City of Richmond
Planning and Development Department

Report to Committee

Date: March 11, 2008
File: 12-8060-20-8332
RZ 07-369284

Re: **Application by Raman Kooner for Rezoning at 11311 Williams Road from Single-Family Housing District, Subdivision Area E (R1/E) to Single-Family Housing District (R1-0.6)**

BRITISH COLUMBIA LAND SURVEYOR'S CERTIFICATE SHOWING EXISTING TREES ON LOT 3 BLOCK 2 SECTION 25 B4N R6W NEW WESTMINSTER DISTRICT PLAN 18935.

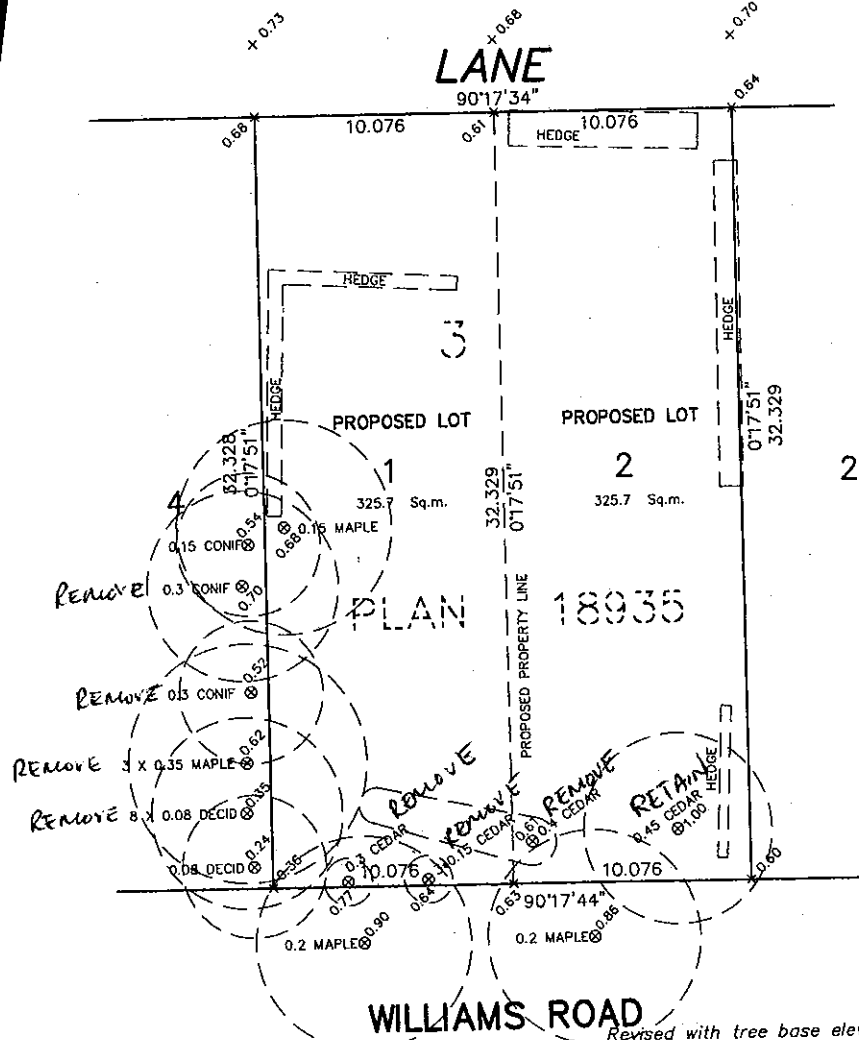
A Tree Survey (**Attachment 3**) submitted by the applicant indicates the location of 13 trees:

- four (4) bylaw-sized trees and one (1) undersized tree on the subject property;
- four (4) bylaw-sized trees and two (2) undersized trees on the adjacent property to the west (11291 Williams Road); and
- two (2) bylaw-sized street trees on City property fronting Williams Road.

A Certified Arborist's report has been submitted by the applicant in support of the application. The report recommends removal of three (3) bylaw-sized trees on-site and retention of the Sequoia tree at the southeast corner of the site. The City's Tree Preservation Coordinator has reviewed and concurred with the Arborist's recommendations for tree removal on the basis of tree condition and conflict with proposed development plans. Based on the 2:1 tree replacement ratio goal stated in the Official Community Plan (OCP), and the size requirements for replacement trees in the Tree Protection Bylaw No. 8057, six (6) replacement trees with the following minimum calliper sizes are required:

Staff also agree that the Sequoia tree should be retained. However, the future dwelling on the eastern lot must be setback 8 m from the front property line to provide additional space for tree and root growth unless the mitigation measures proposed by the Arborist as listed in the Arborist Report Addendum dated Jan 31, 2008 (**Attachment 4**) be implemented. In addition, staff recommend that the Sequoia tree be pruned by a professional arborist for clearance issues and that use of sand-based pavers instead of concrete for any walkways or paths within the front yard of the eastern lot. Installation of retaining walls and perimeter drainage should be hand-dug or installed outside of the tree protection zone. The drainage connection to the eastern lot should be relocated to the western edge of the eastern lot.

The Arborist Report also recommends removal of four (4) bylaw-sized trees located on the adjacent property to the west (11291 Williams Road) – two Maple trees are in poor health, one Hemlock tree is dead, and one Spruce tree is conflict with the proposed development. Although the Spruce tree is in “fair” condition, retention of this tree means a minimum 3.0 m (9.8 ft.) setback from the side property line and a limitation to the wide of a large portion of the future dwelling to 5.8 m (19.0 ft.). Considering this impact to the development potential of the future lot and the applicant’s efforts to protect the Sequoia tree in the front yard, staff support the removal of the Spruce tree.

As a condition of rezoning, a Restrictive Covenant for Tree Protection must be registered on title in order to preserve the Sequoia tree. The Restrictive Covenant will include language to ensure all structures on the future eastern lot are setback 8.0 m from the front property line. The Restrictive Covenant will also include language to allow the front yard setback, including all projections, be reduced to 6.0 m provided that the mitigation measures to prevent root growth beneath the future structures as listed in the Arborist Report Addendum dated Jan 31, 2008 (**Attachment 4**) are implemented. The applicant will provide a security of \$2,000 for tree survival to be held by the City until one (1) year after the Final Building Permit Inspection is undertaken.

The applicant must also submit a proof of contract with Certified Arborist for supervision of on-site works conducted on the subject property within and adjacent to the tree protection zone as identified in the Arborist Report. Tree protection barriers around the Sequoia tree must be installed on-site prior to final adoption or prior to demolition of the existing dwelling on the subject property (whichever occurs first), and remain on-site until the construction of the future dwellings is completed.

ADDENDUM:

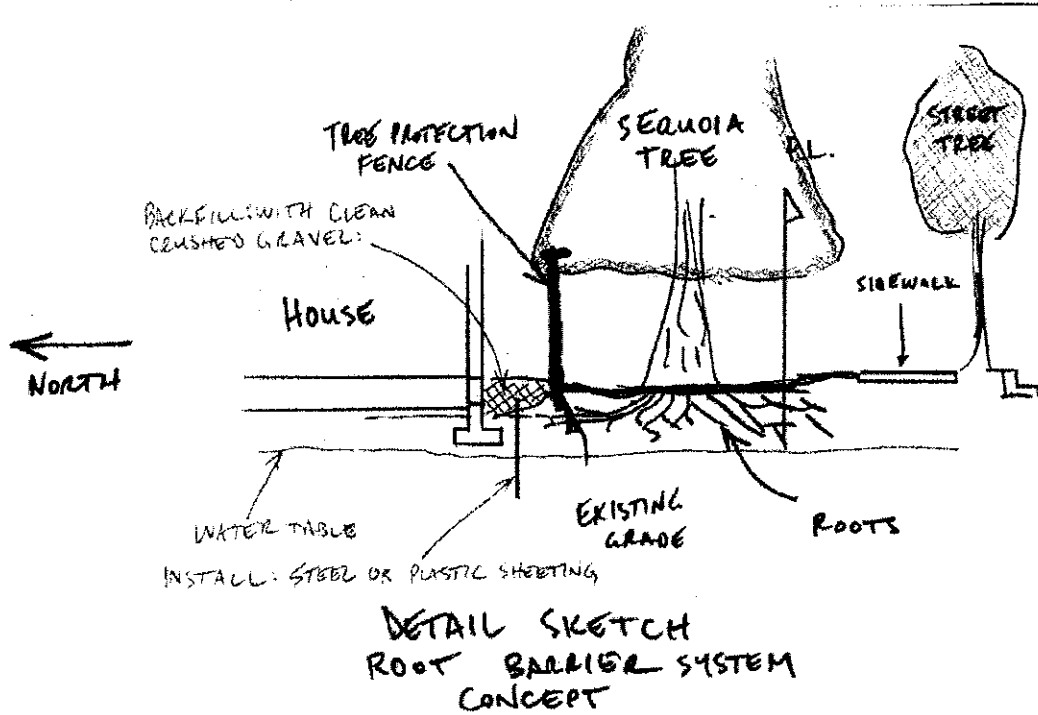
I have received comments from the City review of the Tree Retention Assessment report dated December 19 2007. Further assessment and details are provided below at your request. I reference the points as numbered in the email from Edwin Lee (City) dated January 9 2008. Please forward the revised Tree Retention Plan along with this memo to the City for their records.

1. The two trees must be protected to meet parks department requirements. This is usually a fence to be installed around the sidewalk planter in this type of growing site. Since the site it rear access, it is expected that no building related construction will be undertaken from the front. The service connections may be in conflict with existing trees, however the City crews typically install them to your property line, therefore their own crews should be advised to protect the trees adequately. A note has been added to the plan to address their protection.

2. The protection zone for the Sequoia tree # 536 is a no-access zone as described in the tree protection guidelines on the Tree Retention Plan. Note that a follow-up visit has resulted in a revision to the protection zone to allow sufficient space for underground service connections to be installed on the west side of lot 2 without being in conflict. No retaining walls or perimeter drain can be installed within the tree protection zone.

3. The Sequoia tree dripline is currently 3.5m radius as measured in our field inspection. The tree will eventually grow to have an estimated dripline of 8.0m radius in 30 years. That dripline is shown on the plan for context.

4. The future growth of the Sequoia tree will result in branches growing up to and over a new home constructed to the front yard setback (i.e. 6.0m). This growth can be managed by performing pruning from time to time. The upper foliage that may eventually overhang the house must be left intact, recognizing that additional building maintenance will be required, such as cleaning gutters more regularly than otherwise. All future pruning should be undertaken by a qualified and experienced arborist, certified through the International Society of Arboriculture. The front sidewalk should indeed be constructed using unit pavers instead of concrete so that the future uneven lifting can be easily corrected without hard surface damage and without injuring the roots. The best option would be to provide additional space for tree and root growth on lot 2. For instance, implementing a front yard setback of 8.0m rather than 6.0m will provide relief from encroachments of limbs and roots toward the building. This is not possible without significant detrimental design impacts to the new home.

Root barriers are not always effective, especially in the long term. They may be used at the discretion of the owner. Various products and installation methods are available. This should not be a condition of approval, since there is conflicting research findings in literature as to the usefulness.

For best efficacy to minimize root growth too close to the foundation, I recommend an alternative solution as per the detail below. This method will prevent root growth beneath the barrier by penetrating below the water table, and reduce root growth in the upper stratum by keeping the area inert. The house can be built to otherwise normal standards of construction, to the 6.0m front yard setback without long term impacts.
